## SERVICE BULLETIN

Model: 30RES, 30RYG, and RGEN30

Subject: Low Oil Pressure (LOP) Switch Replacement Service Kit GM69950

**Figure 1** LOP Switch Location

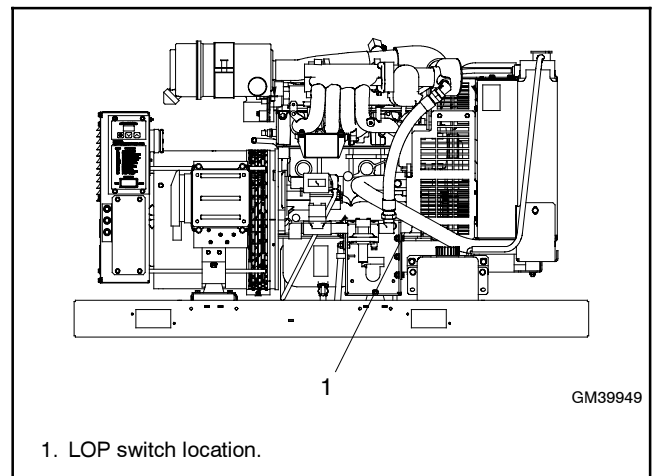
LOP switch 364345 is factory-installed on generator sets with serial numbers above 2243791. See Figure 1 for the LOP switch location on the generator set engine. On generator sets with lower serial numbers or build dates before February 16, 2009, compare the LOP switch to Figure 2 and Figure 3 to determine which type of switch is installed. If the original switch shown in Figure 2 is installed, use service kit GM69950 to replace the LOP switch with switch 364345 and lead GM66559 shown in Figure 3.

**Figure 3** Replacement Switch 364345

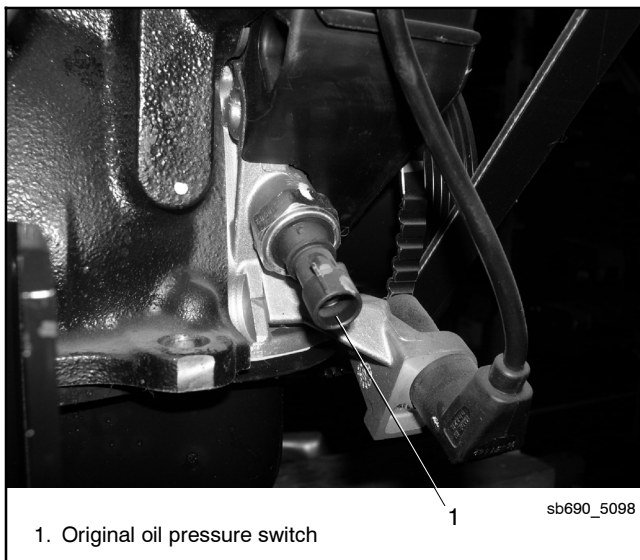
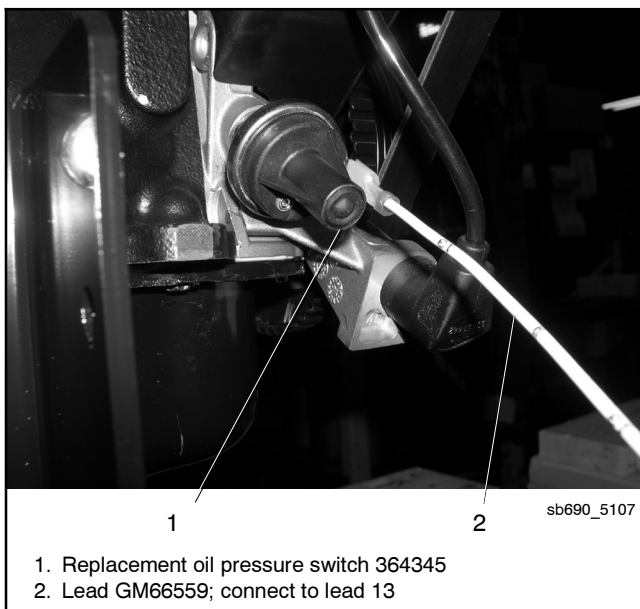
Replacement LOP switch 364345 shuts down the generator set at a higher oil pressure ( $38 \pm 3$  psi) than the original LOP switch. The higher-pressure shutdown provides added protection from major engine damage due to insufficient oil pressure.

7. Install new LOP switch 364345 using the existing copper washer. Use a torque wrench with a 7/8 in. crowfoot to tighten the LOP switch to 30 Nm (22 ft. lbs.).

8. Attach lead GM66559 to the LOP switch and connect to lead 13 of the engine harness (disconnected in step 5).
9. Refill the engine oil and check for leaks.

**Figure 4** Decal GM66054

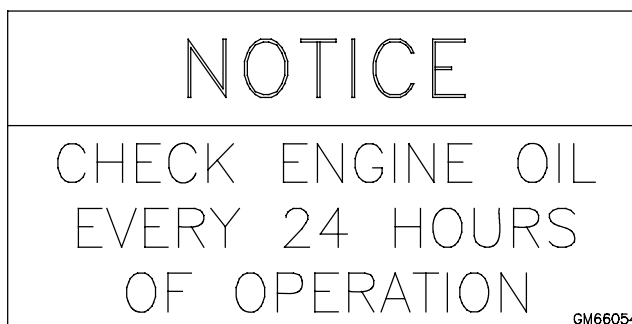
10. Affix decal GM66054 in a convenient location as a reminder to check the oil level regularly. See Figure 4.
11. Check that the generator set master switch is in the OFF position.
